Access Compliance Report

Public Rights-of-Way

Intersection ID: 28969	Main Street: HERON_GLEN_DR	Cross Street: KESTRAL_RIDGE_DR	Location:	N
ADA ID: 8FC816CB6CC6	Ramp Type: BlendTrans1	Initial Pass/Fail: Fail	Overall Compliance: No	Severity Score: 10

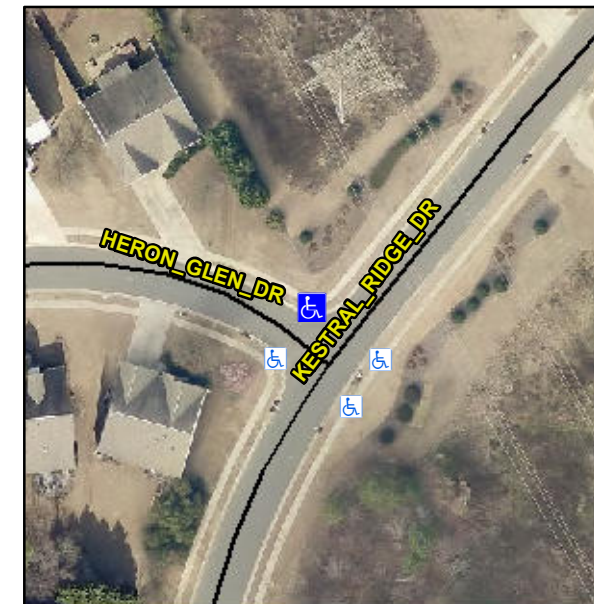
R304.5.1, R304.5.3

Compliance	Description	Data	Compliance	Description	Data
N/A	Ramp Length (in)	49.0	Yes	BlendTrans Slope (%)	2.7
No	Ramp Width (in)	47.0	No	BlendTrans XSlope (%)	2.8
N/A	Flare Type LT	N/A	N/A	Flare Type RT	N/A
N/A	Flare Slope LT (%)	N/A	N/A	Flare Slope RT (%)	N/A
N/A	Flare Traversable LT?	N/A	N/A	Flare Traversable RT?	N/A
N/A	Landing Length (in)	N/A	N/A	DWS Provided?	N/A
N/A	Landing Width (in)	N/A	N/A	DWS Contrast?	N/A
N/A	Landing Slope (%)	N/A	N/A	DWS Length (in)	N/A
N/A	Landing X Slope (%)	N/A	N/A	DWS Full Width?	N/A
N/A	Landing Curb? (Y/N)	N/A	N/A	DWS Offset (in)	N/A
N/A	Shared Landing?	N/A			
N/A	Gutter Ponding?	N/A	N/A	Gutter Slope (%)	N/A
N/A	Gutter Lip Ht (in)	N/A	N/A	Gutter X Slope (%)	N/A
N/A	Painted X Walk1?	No	N/A	Painted X Walk2?	No
	X Walk 1 Direction	To SW		X Walk 2 Direction	To SE
	X Walk 1 Width (in)	N/A		X Walk 2 Width (in)	N/A
	X Walk 1 Slope (%)	2.1		X Walk 2 Slope (%)	3.3
	X Walk 1 X Slope (%)	2.5		X Walk 2 X Slope (%)	2.3

N/A	Ramp inside XWalk1?	N/A	N/A	Ramp inside XWalk2?	N/A
	Road Slope (%)	2.4		Clear Space?	N/A
	Road X Slope (%)	2.0	N/A	Clear Space to XWalk (in)	N/A
N/A	Any Obstructions?	N/A	N/A	Storm Grate/Utility Hazard?	N/A
	Obstruction Type			Storm Grate/Utility Type	
		N/A			N/A
			Yes	Surface Condition? (G/P)	Good
			N/A	Curb Slope (%)	4.8

Remove & Replace Curb Ramp With Two New Directional Ramps or Equivalent.
